Access Compliance Report

Public Rights-of-Way

(Curb Ramps)

Intersection ID: N/A	Main Street: MCALWAINE_PRESERVE_AV	Cross Street: BLAKENEY_PROFESSIONAL_DR	Location: NW
ADA ID: 14364B89B2B0	Ramp Type: PerpDiag	Initial Pass/Fail: Fail	Overall Compliance: No
Severity Score: 21.25			
Codes/Mitigation Info/Possible Solution		Field Measurements/Component Compliance

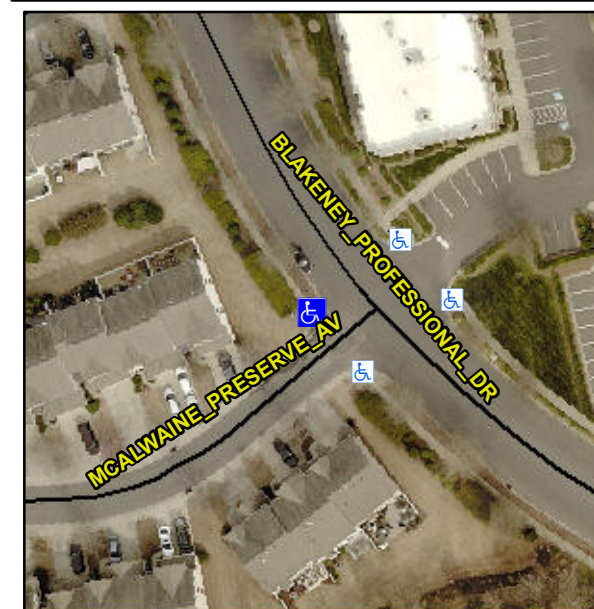
R304.5.1, R304.5.3

Compliance	Description	Data	Compliance	Description	Data
N/A	Ramp Length (in)	70.0	Yes	Ramp Slope (%)	5.2
No	Ramp Width (in)	42.0	No	Ramp XSlope (%)	6.6
N/A	Flare Type LT	N/A	N/A	Flare Type RT	N/A
N/A	Flare Slope LT (%)	N/A	N/A	Flare Slope RT (%)	N/A
N/A	Flare Traversable LT?	N/A	N/A	Flare Traversable RT?	N/A
N/A	Landing Length (in)	N/A	N/A	DWS Provided?	N/A
N/A	Landing Width (in)	N/A	N/A	DWS Contrast?	N/A
N/A	Landing Slope (%)	N/A	N/A	DWS Length (in)	N/A
N/A	Landing X Slope (%)	N/A	N/A	DWS Full Width?	N/A
N/A	Landing Curb? (Y/N)	N/A	N/A	DWS Offset (in)	N/A
N/A	Shared Landing?	N/A			
N/A	Gutter Ponding?	N/A	N/A	Gutter Slope (%)	N/A
N/A	Gutter Lip Ht (in)	N/A	N/A	Gutter X Slope (%)	N/A
N/A	Painted X Walk1?	No	N/A	Painted X Walk2?	No
	X Walk 1 Direction	To SE		X Walk 2 Direction	To NE
N/A	X Walk 1 Width (in)	N/A	N/A	X Walk 2 Width (in)	N/A
	X Walk 1 Slope (%)	0.5		X Walk 2 Slope (%)	4.6
	X Walk 1 X Slope (%)	0.6		X Walk 2 X Slope (%)	1.4

Remove & Replace Curb Ramp With Two New Directional Ramps or Equivalent.
